Diversified Metal Fabricators Service Bulletin SB 2080

Title	RW-1650GX, GRADALL XL3330-V & XL4330-V OUTER STRUCTURE REINFORCEMENT
Document No.	SB2080 Rev A
Issue Date	05/28/20 (BJF)
Release	As Needed
S/N Affected	45958, 45959, 46218, 46219, 46220, 46221, 46302, 46303, 46522, 46523, 46663, 46664, 46828, 46829, 47004, 47005, 47024, 47025, 47104, 47105
Purpose	Provide guidance to inspect and reinforce outer structure to prevent cracks.

Figure 1 - Outer Structure Weldment Gradall XL-3300

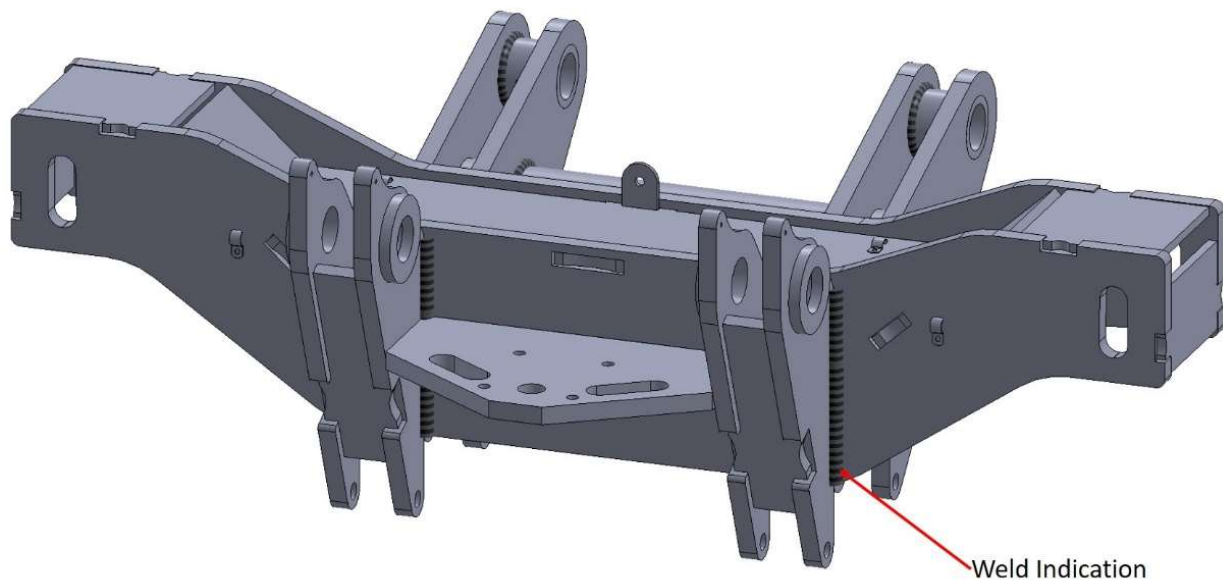
The following figures show the structural welds requiring inspection. Inspect all the welds noting any that may have cracked. All striped patterns in the figures represent required welds.

Any missing, or partial welds should be welded as shown. To repair cracked welds, grind flush all of the old weld material. Ensuring all cracks have been removed before adding a new weld. The weld sizes have been called out in each figure. Some of these welds require additional passes to increase fillet size from 1/2" to 7/8". For these specific welds, the weld symbol has been highlighted and noted in Figure 2 and Figure 3.

Figure 4 - Weld Inspection Inner Welds

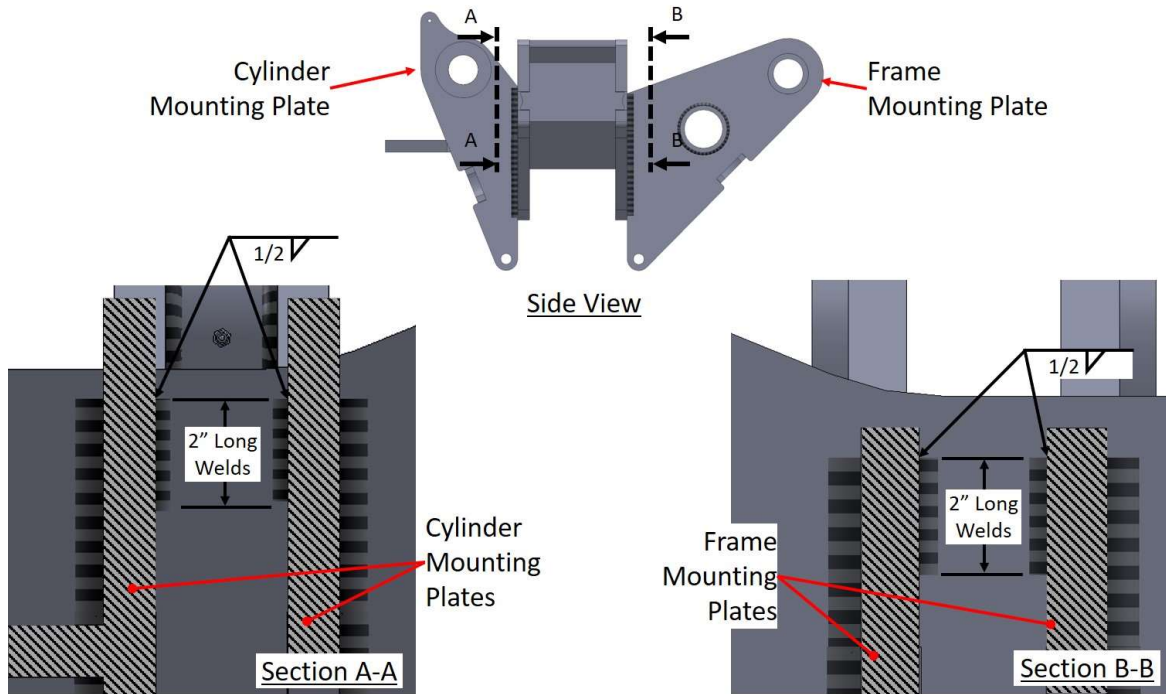
Figure 4 shows 2" long welds found between the Cylinder Mounting Plates at the front and the Frame Mounting Plates at the rear. These also need to be inspected and repaired if necessary.

Figure 5 - Gusset Weld Specification

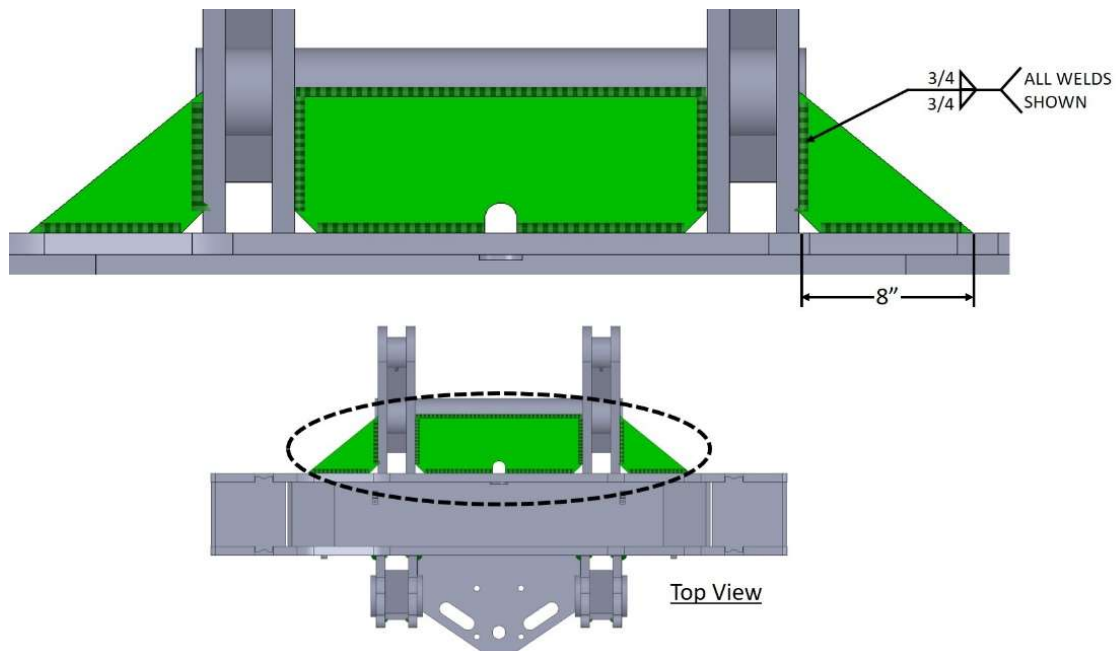
For additional strength, contact DMF for Gusset Kit P/N 835223. These parts, which have been shown in green, include two gussets and a cross support for both the front and rear railgear. All are welded to the backside of the weldments. Use a 3/4" fillet on both sides as shown, see Figure 5 and Figure 6.
